# Barton Springs Pool

## Current Schematic Plan

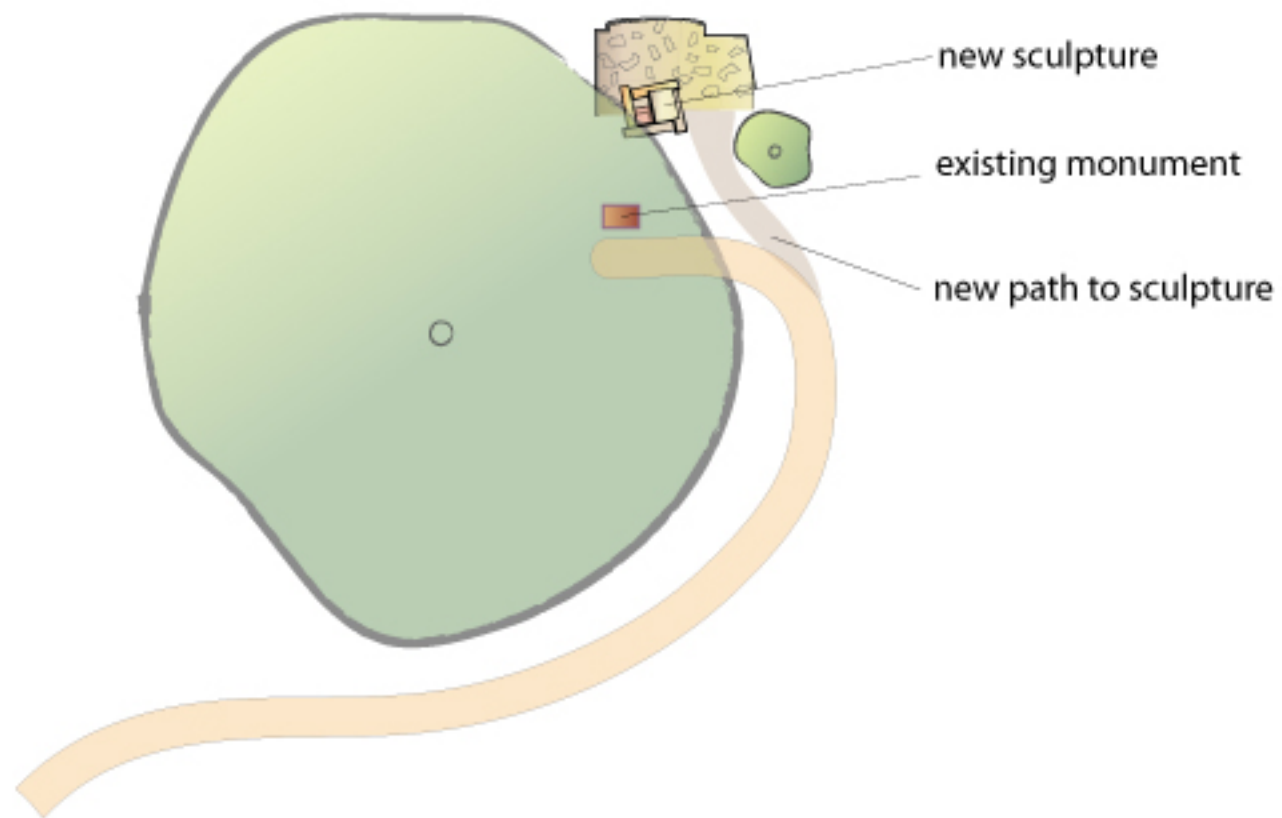
AIPP artwork is being proposed to be placed approximately where the "E" is. Artwork would eliminate 12-foot circular overlook pad.

1. Relocated Pathway to Area E outside Critical Root Zone of trees.
2. Reduced Diameter of Stone area at Overlook from 18' to 12 feet.
3. Relocated Bike Parking area to front on Hike and Bike Trail.
4. Modified South Entry Gate and Stone Columns.
